8.14.23 CHANGE AS PER ECN 23-138

KEYSTONE ELECTRONICS CORP.			
www.keyelco.com • NEW HYDE PARK, NY 11040 • Tel (516) 328-7500			
PART NAME			
20mm - 21mm BATTERY CLIP			
MATERIAL			
.012 [0.30] TH'K ANNEALED SPRING STEEL			
FINISH		DRN BY	DATE
TIN NICKEL PLATE		NT	10.11.17
		APP'D	SCALE
		RH	2X
TOLERANCES	INCH	CODE	DWG NO.
DECIMAL	$\pm .010 [\pm 0.25]$	C	
ANGULAR	$\pm 2^\circ$		
UNLESS OTHERWISE SPECIFIED

247

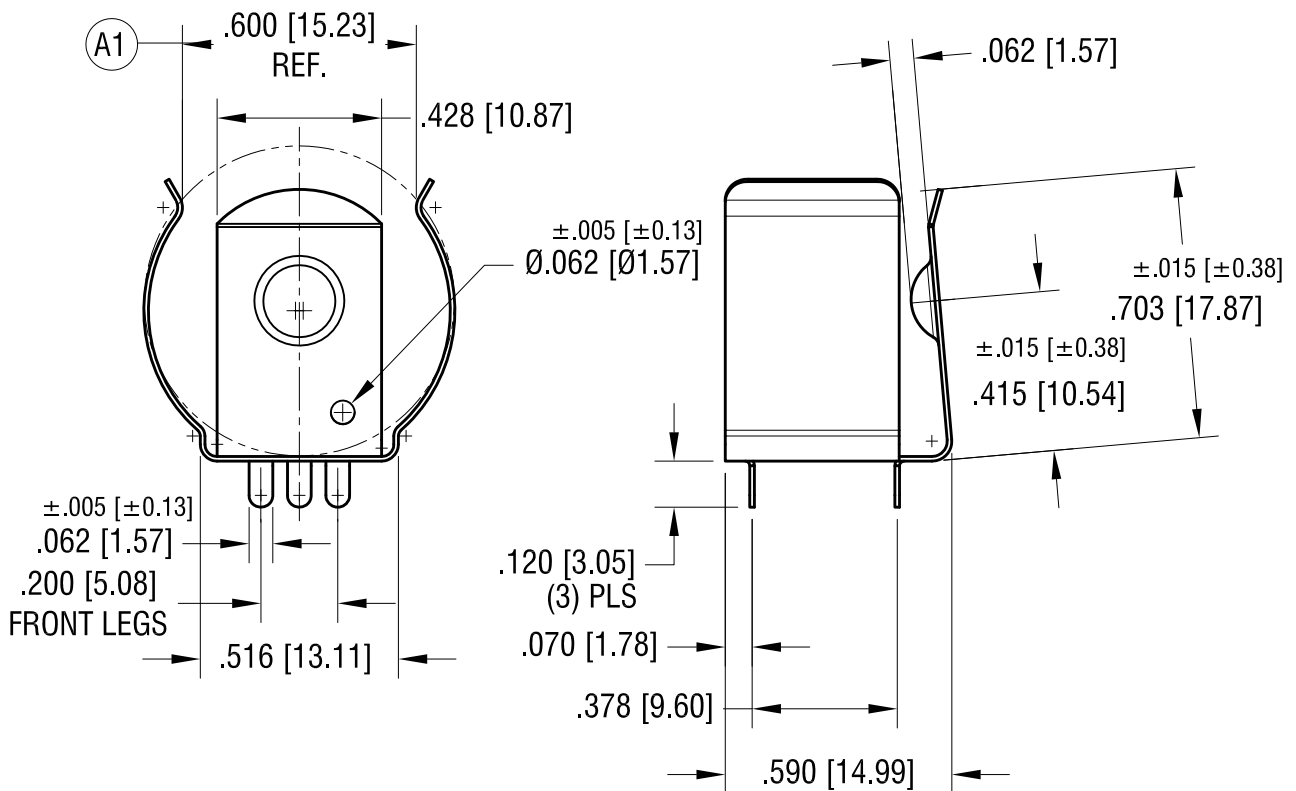
(A1) WAS .609 REF.
